FIRE DEPARTMENT

Re: Review of Rooftop Access Plan
170-06 Crocheron Avenue, Queens, NY 11358
Block:5301 Lot: 33 **Bin # 4119879**
Fire Prevention FPIMS No. 37193448
BQ04084A . L700
GRANTED

1 FIRE CODE ROOF PLAN
FPP-002 SCALE: NTS

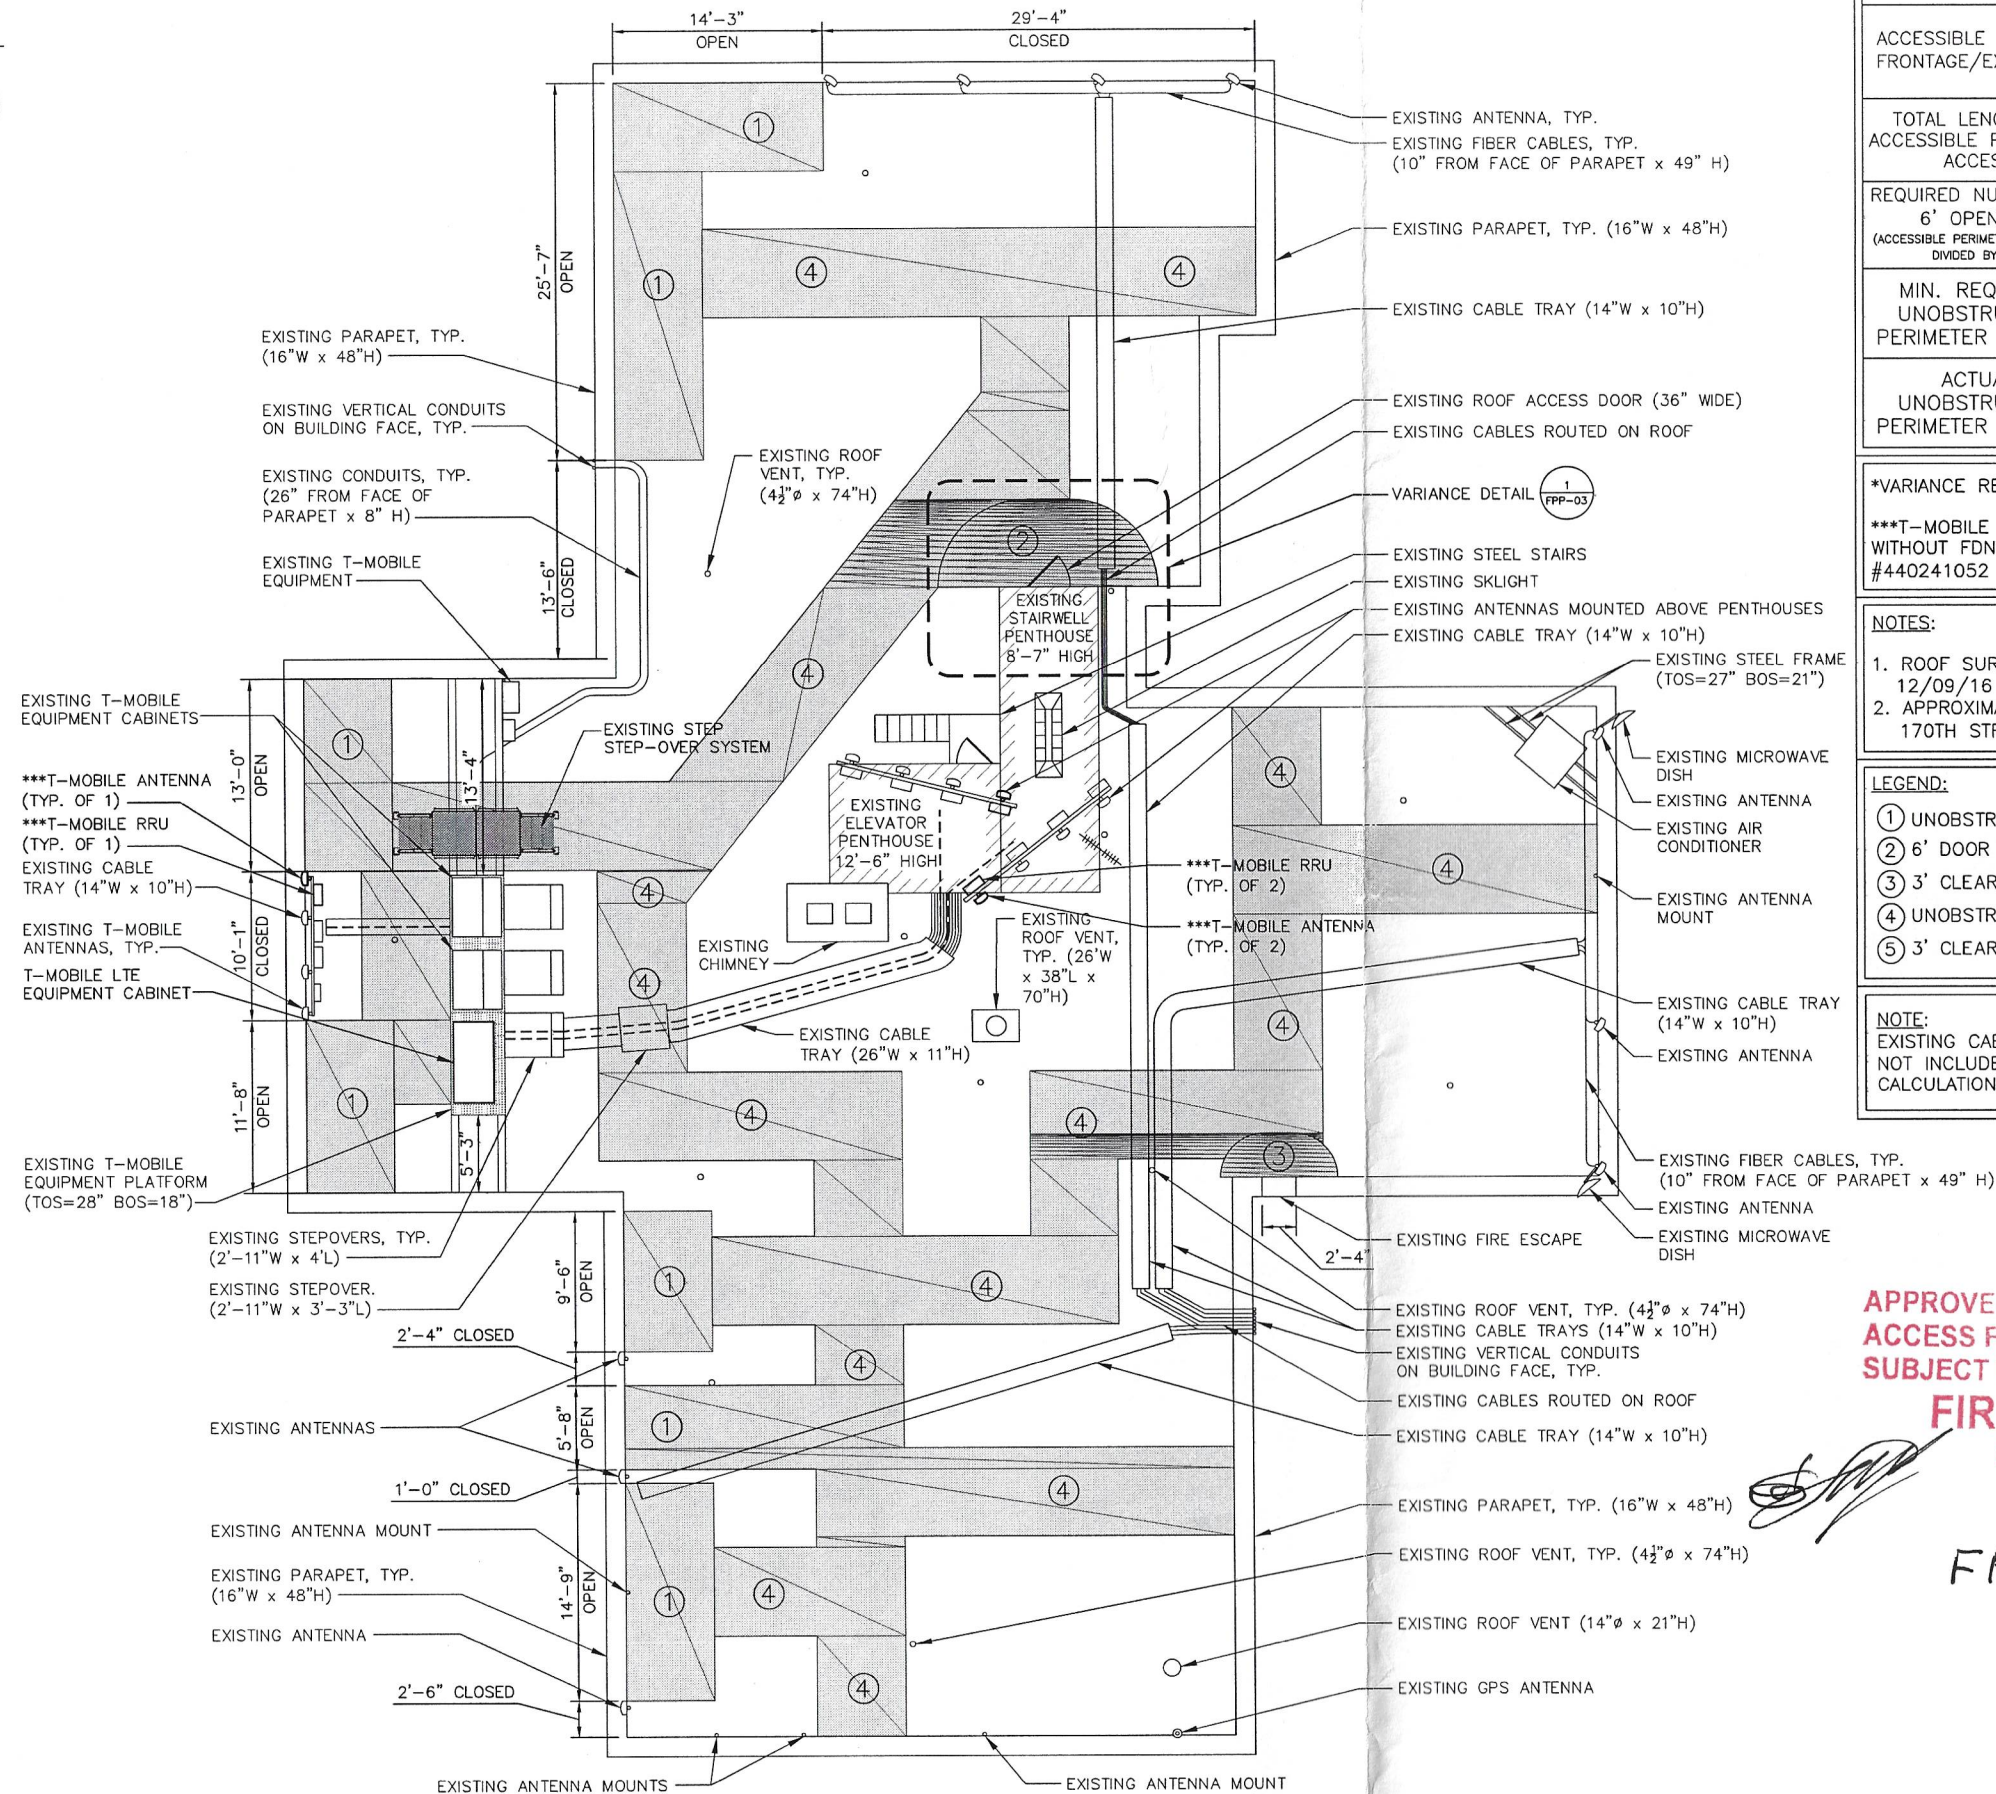
Your modification application and accompanying rooftop plan **FPP-002.00 REV 0** dated **06/01/2017** indicates that you are unable to comply with the minimum clearance and design requirements for rooftop access and/or clear path requirements of FC 504.4 primarily because of the following existing rooftop condition and/or proposed rooftop alteration:

- Existing T-Mobile antennas, Clearwire antennas, conduits limit rooftop perimeter access along Crocheron Avenue and 170th Street exposures.
- Existing T-Mobile equipment platform, cable trays, conduits, step overs, steel frame limit clear path access from front to rear and from side to side on rooftop.

In lieu of complying with FC504.4, your rooftop plan **FPP-002.00 REV 0** dated **06/01/2017** provides 93' of rooftop perimeter access on the Crocheron Avenue and 170th Street exposures, connected to a clear path from the front of the building to the rear and from one side of the building to the other.

Your rooftop plan **FPP-002.00 REV 0** dated **06/01/2017** provides adequate Fire Department access to and upon the rooftop. Accordingly, your application for a modification is **GRANTED**, subject to the following conditions:

1. This determination only modifies compliance with respect to the rooftop access and/or clear path requirements specifically set forth above. This determination does not modify your obligation to comply with other applicable provisions of FC504.4, including the marking and signage requirements of FC504.4.7 and 504.4.8.

3. The approved modified rooftop access and/or clear path requirements as indicated on architectural drawing **FPP-002.00 REV 0** dated **06/01/2017**, shall be constructed and maintained in accordance with the approved rooftop plan and maintained clear of obstructions and kept available for emergency responders. If any change is necessary, a new application shall be submitted to modify them.
